## COMMITTEE REPORT

BY THE EXECUTIVE DIRECTOR FOR ECONOMIC GROWTH AND NEIGHBOURHOOD SERVICES  
READING BOROUGH COUNCIL  
PLANNING APPLICATIONS COMMITTEE: July 21<sup>st</sup> 2021

App No.: 210018

Proposal: Outline planning application, with matters reserved in respect of Appearance, for demolition of the existing clubhouse and the erection of a new residential-led scheme (C3 use to include affordable housing) and the provision of community infrastructure at Reading Golf Club

**READING GOLF CLUB SITE ACCESS LAYOUT - Drawing 45675/5510/001A REV A**

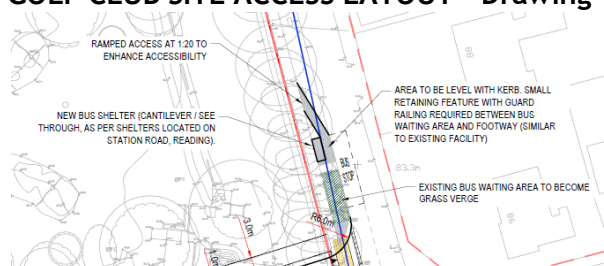
In accordance with the Council’s Design Guidance, visibility requirements for new junctions onto classified road are 2.4m x 70m for local transport corridors. Visibility splays have been demonstrated on **Drawing 45675/5510/001**. In terms of design, the layout of the primary access serving the residential accommodation is acceptable and complies with adopted policy.

The existing northbound stop will need to be modified as it lies between the new site access to the south and the new GP Surgery to the north. A concept layout for an improved bus stop design with shelter and levelled access can be seen in Drawing 45675/5510/001A. The concept layout includes a ramped access from the northern approach, however, the applicant should investigate whether steps or a ramp could also be accommodated the southern approach as currently provided. It is proposed that the detail design of the bus stop is secured via condition prior to commencement which is acceptable to the Highway Authority.

#### READING GOLF CLUB SECONDARY ACCESS LAYOUT

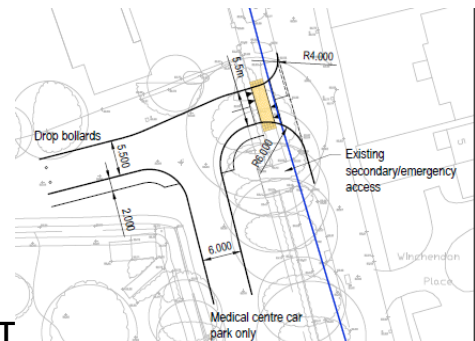
A secondary access will be located on the eastern boundary of the site providing access only to the health centre and apartments above it. It is noted that this access has been retained (currently providing emergency access for Reading Golf Club), however it has been slightly relocated and improved to include a footway and informal crossing with tactile paving.

The secondary access junction allows direct access to the health facility and reduces the impact of additional trips by all modes entering and exiting the residential development via the main access junction. This access will also form an emergency access with a droppable bollard into the site. The junction design can be seen in **Drawing 45675/5510/003**.
